**Re: Rapiscan AIT System Radiation Survey Reporting**

<b>Secure 1000 Radiation Emission Measurement</b>	FORM R-0646-1 (Single Pose)
--	---------------------------------------------------	--------------------------------

**R-0646-1 Addendum  
(Documentation Errors)**

Product Name	Secure 1000SP (Single Pose)
Serial Number	<b>S51024011</b>
Radiation Emission Measurement	Radiation Survey Dated: 11/12/2010
RSO Initials

### 1. In Beam Dose Measurement: Survey Table. 1

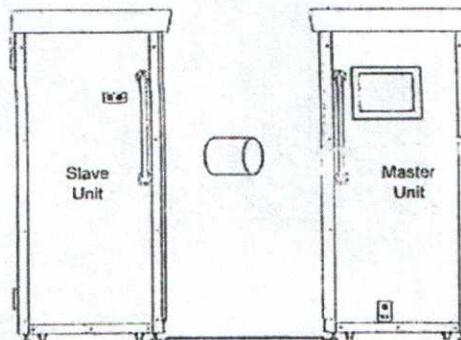
1. No value indicated for background radiation. Typical values range from 7uRem/hr to 13uRem/hr at sea level. Note: Absence of value has no adverse impact on calculations.
2. TABLE 1: Incorrect presentation of data in Column 3 for Measured Exposure. Indicated values are 25uR and 25uR. Corrected values are 2.5uR and 2.5uR
3. TABLE 1: Incorrect presentation of data in Column 6 for Effective Dose. Indicated values are 14 uRem and 14 uRem. Corrected values, per RSO corrections, are 1.4 uRem and 1.4 uRem.
4. Technician did not initial pass or fail check box.

The service technician should attend refresher training.

The corrected report indicates the system is within limits for applicable compliance and safety standards. No re-survey is required for this system.
